CITY OF MISSISSAUGA
PLANNING AND BUILDING
Drawings Approved For Compliance With Ontario Building Code And Mississauga Zoning By-law
Subject to the Conditions Shown Below
PERMIT NO. EP 34LT 18-3566
2018-12-13
SIGNATURE
B. SAVINI, P.Eng. CHIEF BUILDING OFFICIAL

PROJECT: LAVISH LOOKS BEAUTY SALOON
62 QUEEN STREET S. MISSISSAUGA

DRAWING: PROPOSED SECOND FLOOR PLANS

A-03

PROPOSED GROUND FLOOR PLAN

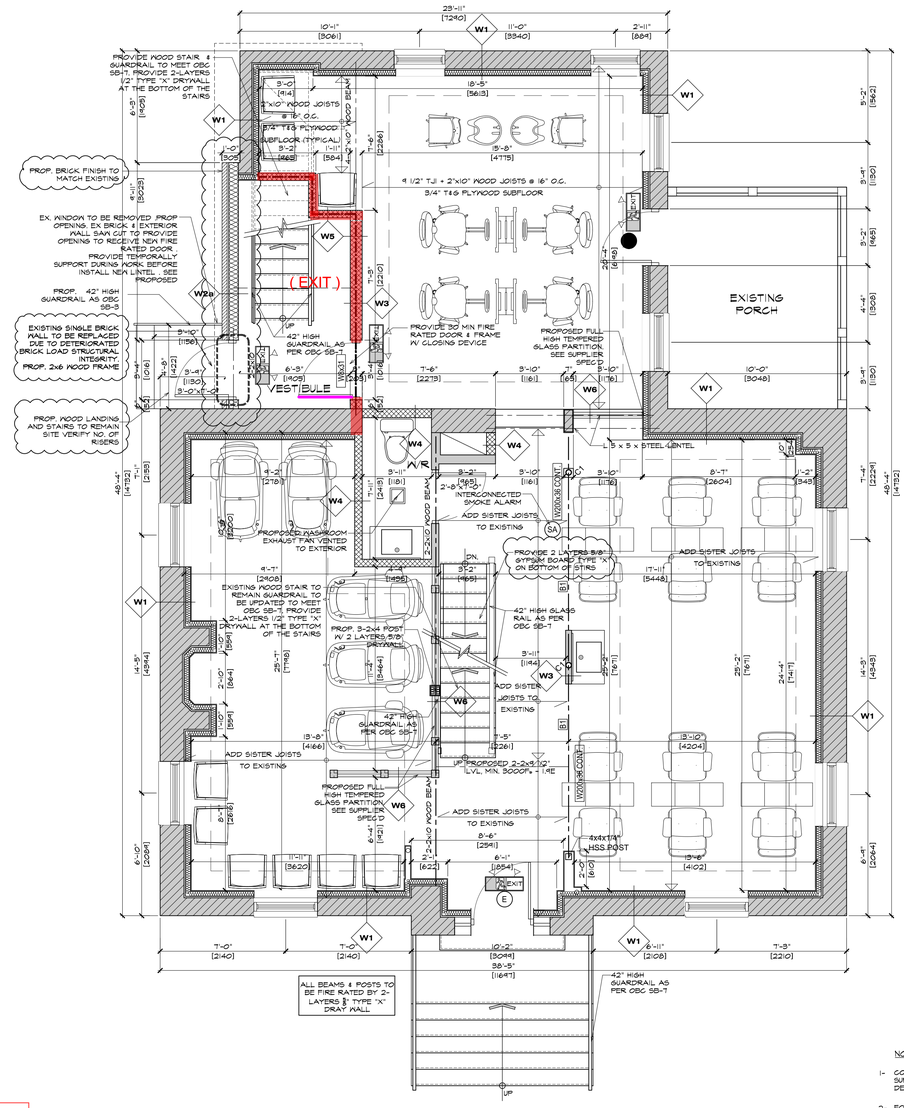
NOTE: There are no structural alterations under this permit application as per discussion with the Architect.

PROPOSED SECOND FLOOR PLAN

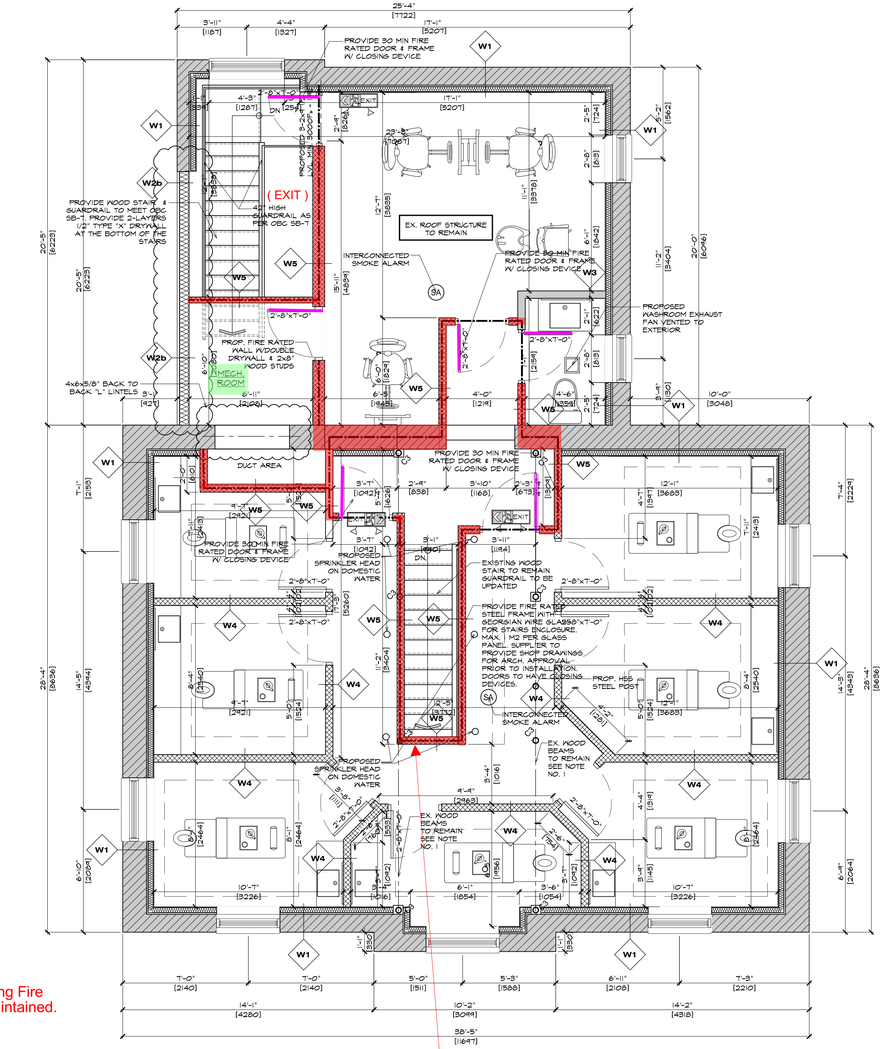
W5 — PROP. INTERIOR PARTITION WALL U/S ~~CONC SLAB~~ Deck above
DESIGN ULC W407 FIRE RATED
- 1 LAYER 5/8" DRYWALL
- 2x4" ~~WOOD~~ STUDS @ 16 O.C. (Steel Studs)
- 1 LAYER 5/8" DRYWALL

45 Minute Fire Separation is required but 1 hr. is provided based on ULC Design no. W407
